Group 2 Remedial Design/Remedial Action Work Plan Addendum 2 for the TSF-09/18 V-Tanks and Contents Removal, Phase 1 Contents Treatment, and Site Remediation at Test Area North, Waste Area Group 1, Operable Unit 1-10

DOE/NE-ID-11150
Revision 3
Project No. 22901

REVISION RECORD

Figure 2. V-Tank sites at Test Area North.

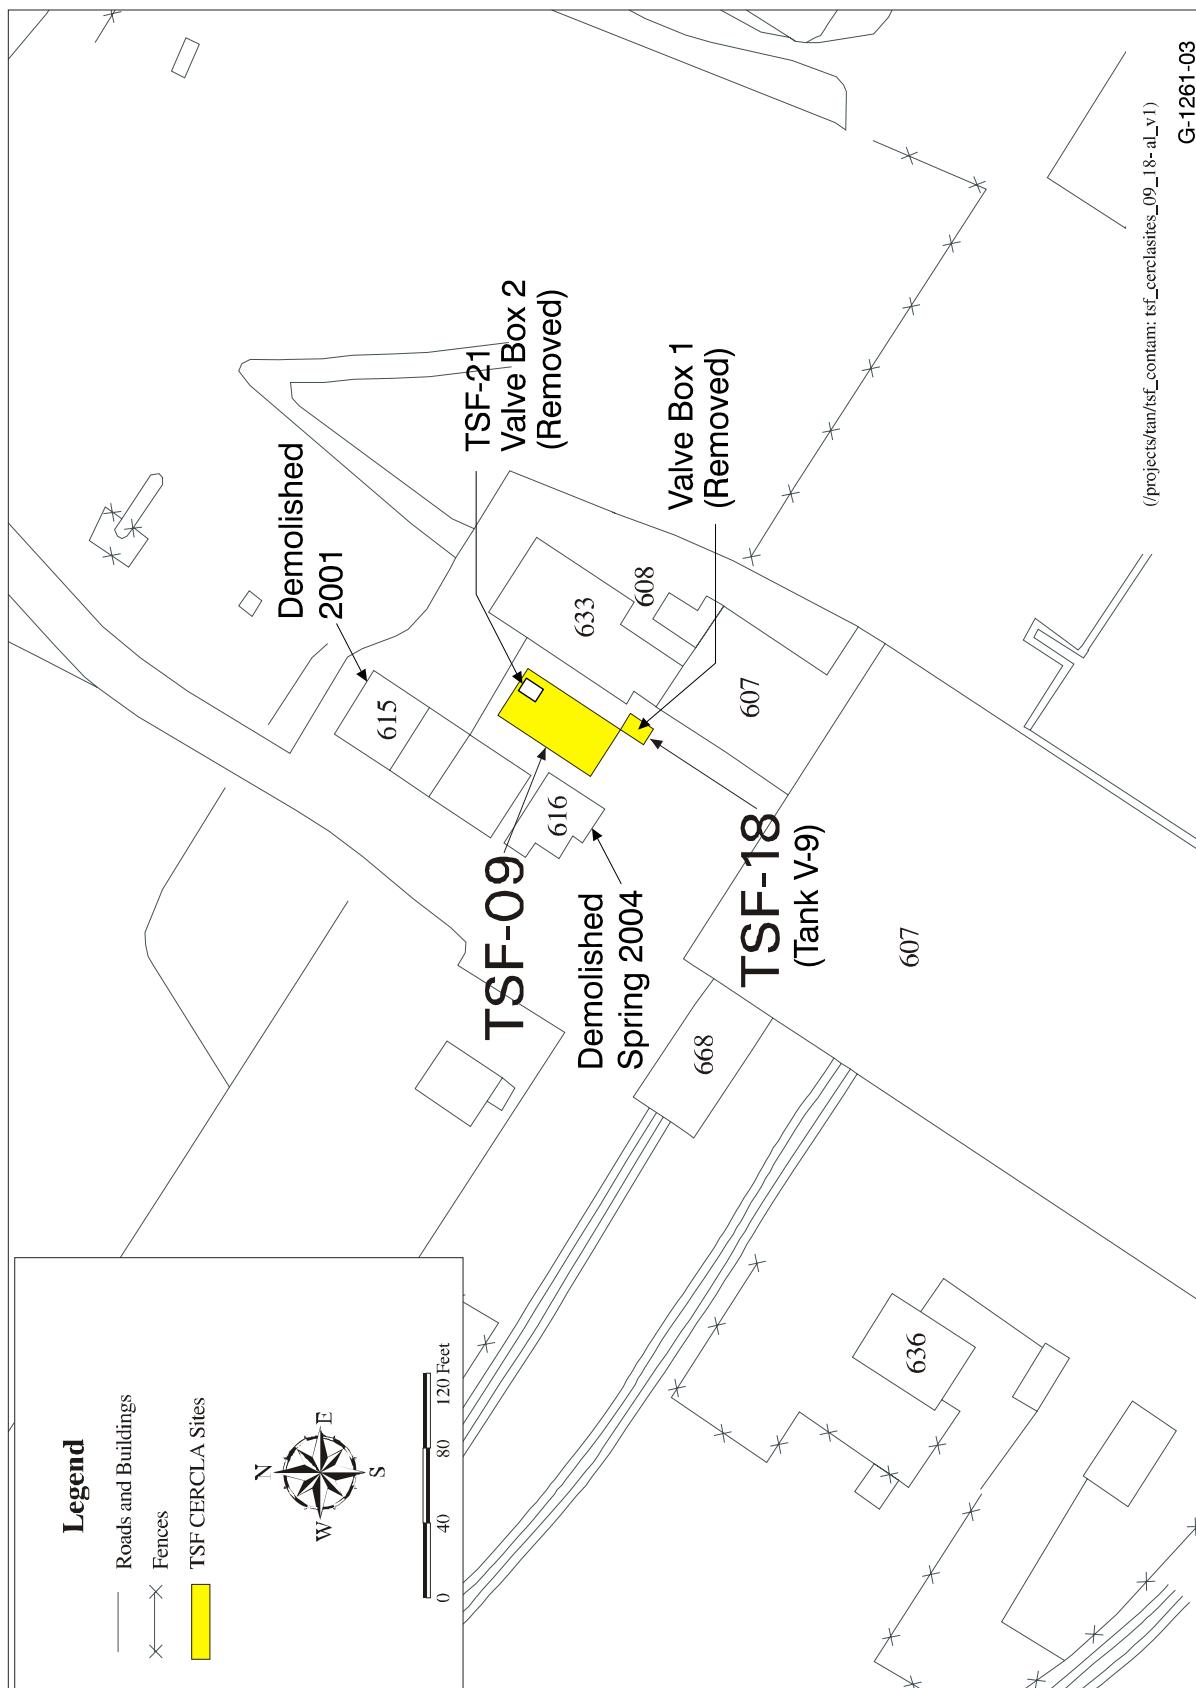
SPECIFIC COMMENTS							
1	1.2.1	8				Page 8, Section 1.2.1, first paragraph, first sentence. Since the text within this document addresses such items as valve pits 1 and 2, please include at least a general notation/indicator in the figure of the former locations of TSF-21 and TDF-1704	Incorporated into Figure 2.
2	1.2.1.1	10				Page 10, Section 1.2.1.1, third paragraph. To state "Liquid level measurements in Tanks V-1 and V-2 have remained relatively constant (DOE-ID 1997)." while citing a reference that is out-of-date seems contradictory. Please reference information that cites levels for Tanks V-1 and V-2 through as recent a date as possible.	Incorporated. Reference to EDF-3067 was added. That EDF, written in 2001, discusses the variations in the level and attributes the minor variations to line condensation.

Figure F-1. Conceptual design for Tank V-9 macroencapsulation.

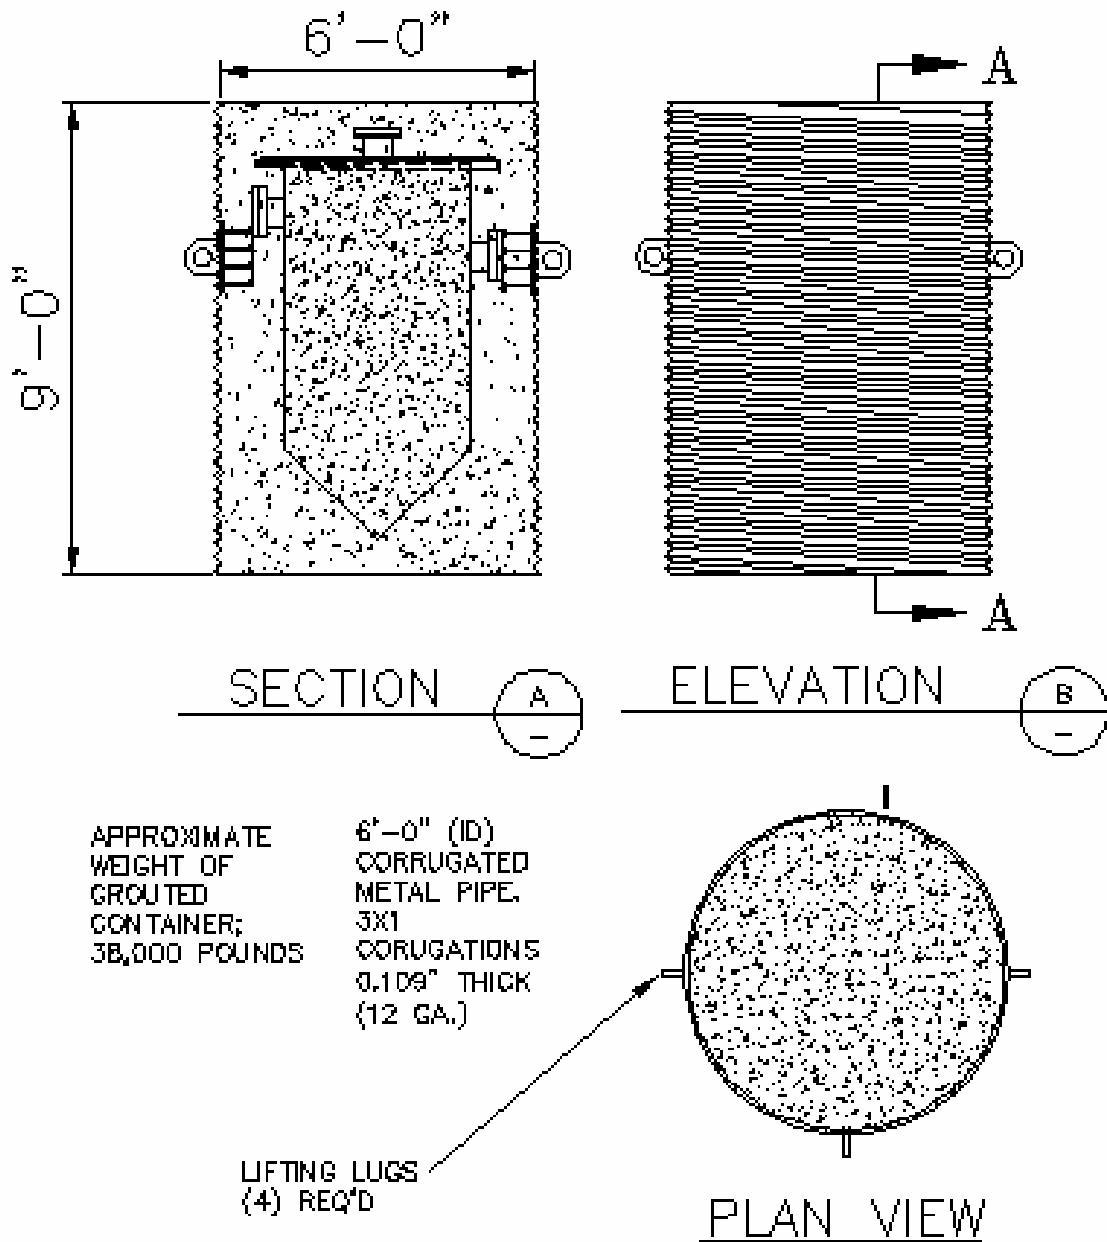
24	Appendix G	G-3				Page G-3, Appendix G. Macroencapsulation of V-9 has not been described in detail, and Figure G-1 provides only minimal details as to the specifics of encapsulation of V-9 if necessary (due to incomplete removal of the contents). This could probably be better treated as a contingent remedy and described in detail, with the appropriate figures, when the need arises.	Comment noted: Macroencapsulation is a contingent measure. If macroencapsulation is needed, we will develop work control documents to address the revised approach. Those documents will be available to the Agencies upon request.
25	DWG C-2					Drawing Sheet C-2, Site Plan. For the sake of clarity and relative positioning of target units, please add labels and arrows to the two other sites, namely "Sites 1 and 2", similar to what was provided on Sheet C-6. Also, please label the dotted line just east of the future soil stockpile area.	Incorporated. Labels were added for Sites 1 and 2 and the dotted line.
